Addendum #2

To: Interested Vendors
From: Matt Lindner – Plante Moran
Date: January 26, 2022
Re: GPPSS VoIP System RFP

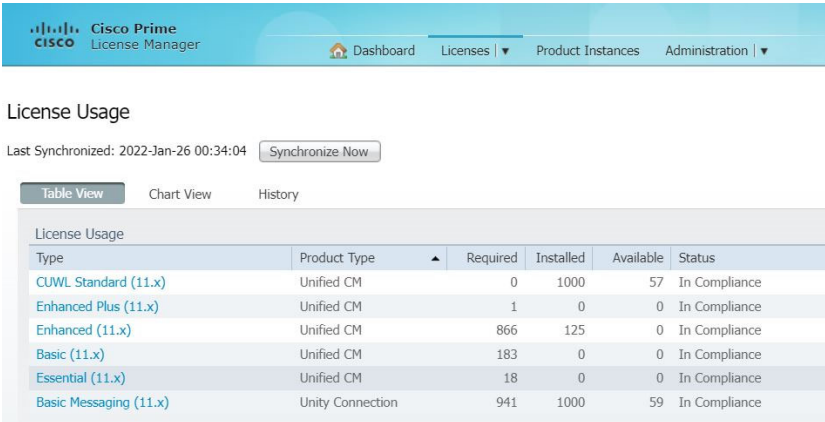
Q: Can you provide a screenshot of your existing licensing usage in Prime License Manager (PLM)?

A: Screenshot provided:
